Docket Nos.: 52-025
52-026

ND-17-1726
10 CFR 50.90
10 CFR 52.7

**Southern Nuclear Operating Company
Vogtle Electric Generating Plant Units 3 and 4
Request for License Amendment and Exemption:
Changes to Tier 2* Departure Evaluation Process (LAR-17-037)**

Proposed Tier 2* Departure Evaluation Process

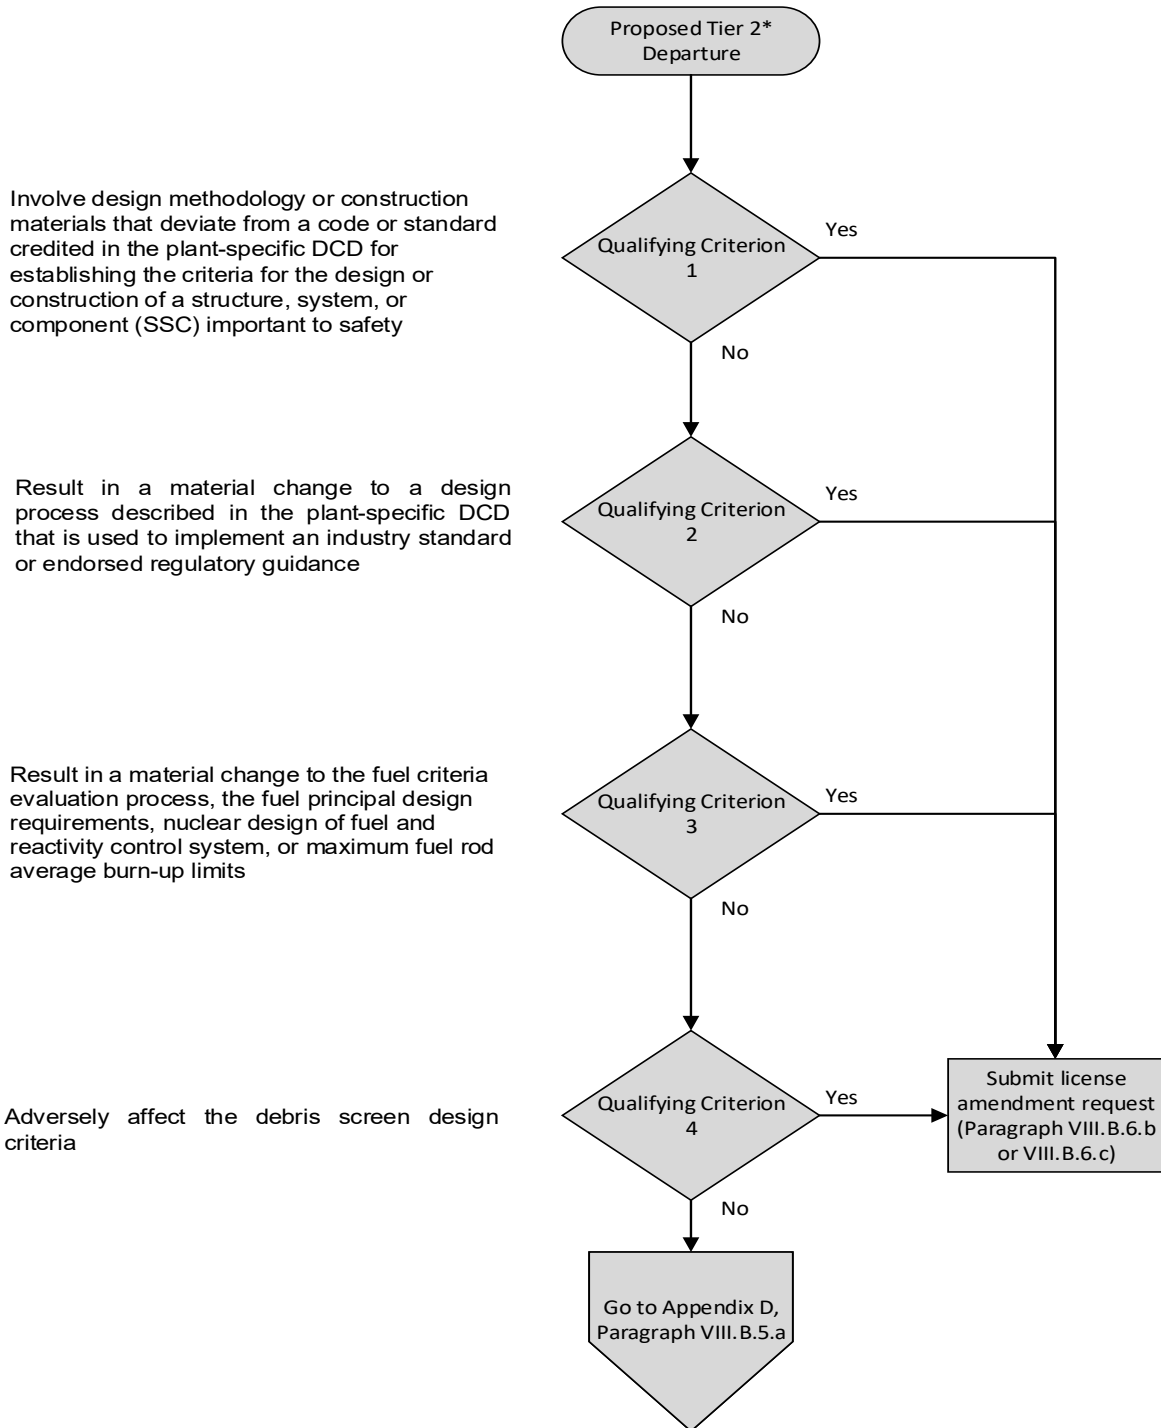
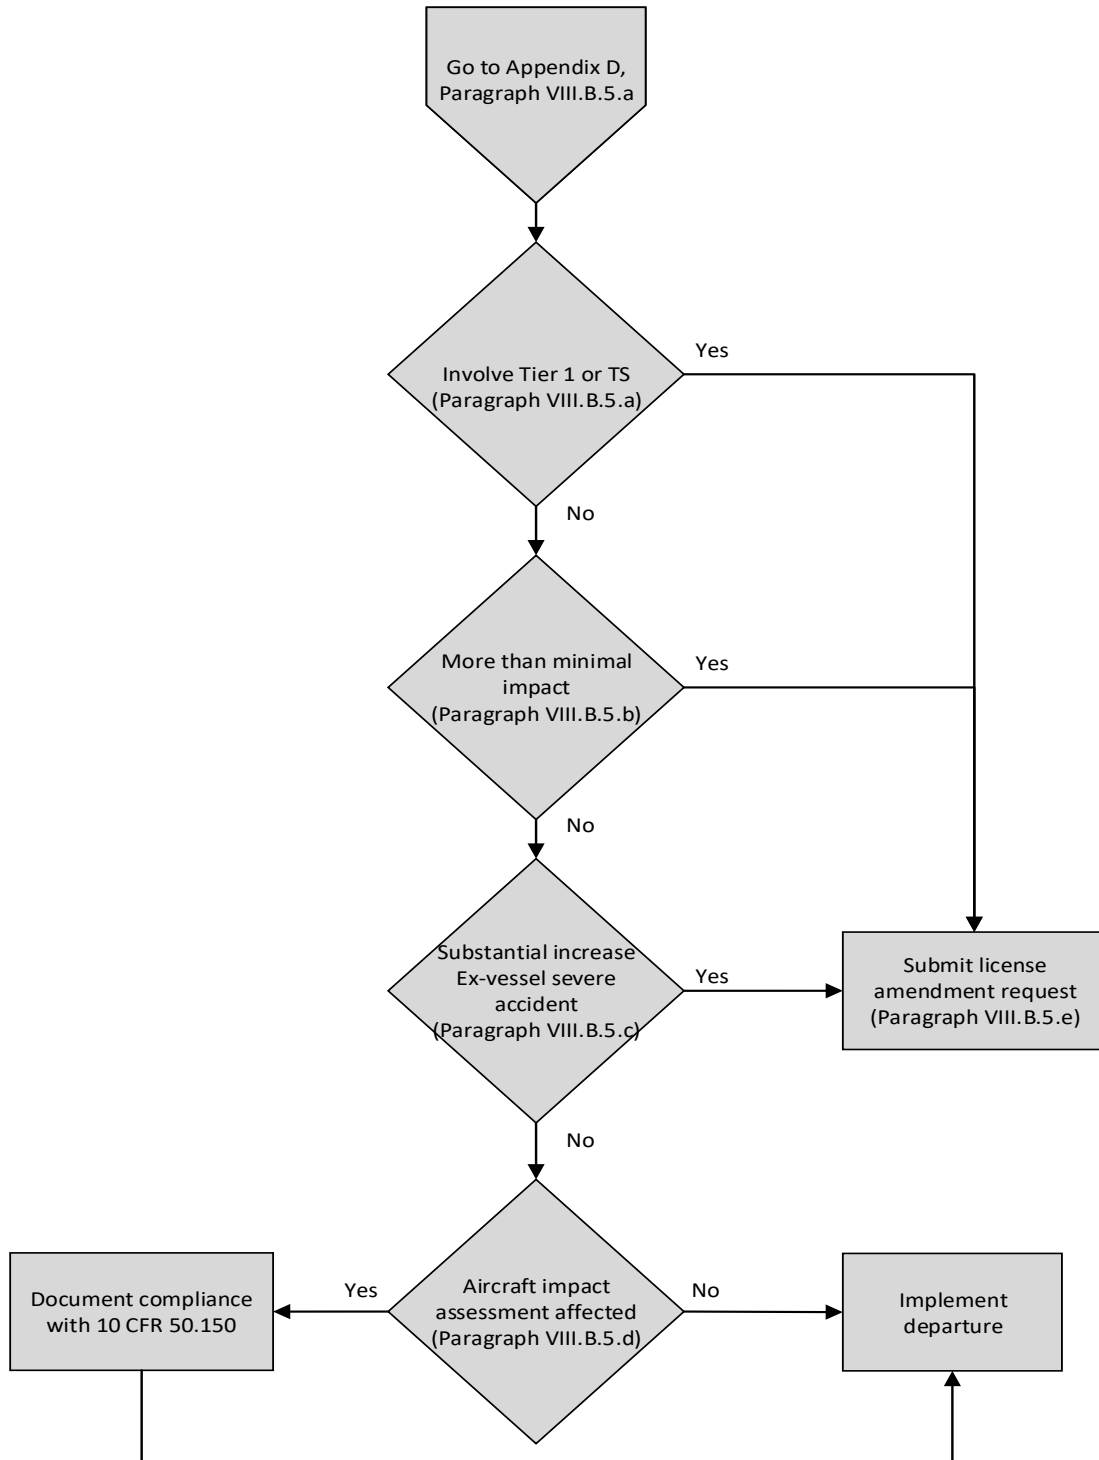
Under the current departure evaluation process applicable to Tier 2* information described in 10 CFR Part 52, Appendix D, Paragraph VIII.B, SNC must seek prior NRC approval through a License Amendment Request (LAR) for any proposed change to Tier 2* information, even if SNC can demonstrate that the change results in no more than a minimal impact to safety or improves safety. As the NRC staff has recently recognized in SECY-17-0075, "Planned Improvements in Design Certification Tiered Information Designations," [ADAMS Accession Number ML16196A321], "One specific lesson is that some information has been designated as Tier 2* when other regulatory tools could have been used instead to ensure a facility is safely designed, constructed and operated. This results in licensees submitting license amendment requests (LARs) on topics that may not involve safety significant facility changes." This is consistent with SNC's experience with the Tier 2* departure evaluation process. In order to mitigate the regulatory inefficiency associated with this issue, SNC proposes a site-specific permanent exemption and license amendment that would use new screening criteria to determine whether a proposed Tier 2* departure would qualify to utilize the Tier 2 departure evaluation process. Qualifying Tier 2* departures would be evaluated under the existing Tier 2 departure evaluation process. Non-qualifying Tier 2* departures would continue to require prior NRC approval. Thus, any safety-significant Tier 2* departure would require prior NRC approval. A diagram of the proposed process is shown in Enclosure 4.

If the screening criteria are all answered no, the proposed change would be considered a “Qualifying Change” and would be processed in accordance with the Tier 2 departure evaluation process specified in 10 CFR Part 52, Appendix D, Paragraphs VIII.B.5.a through VIII.B.5.e (See Enclosure 4 for a proposed process diagram).
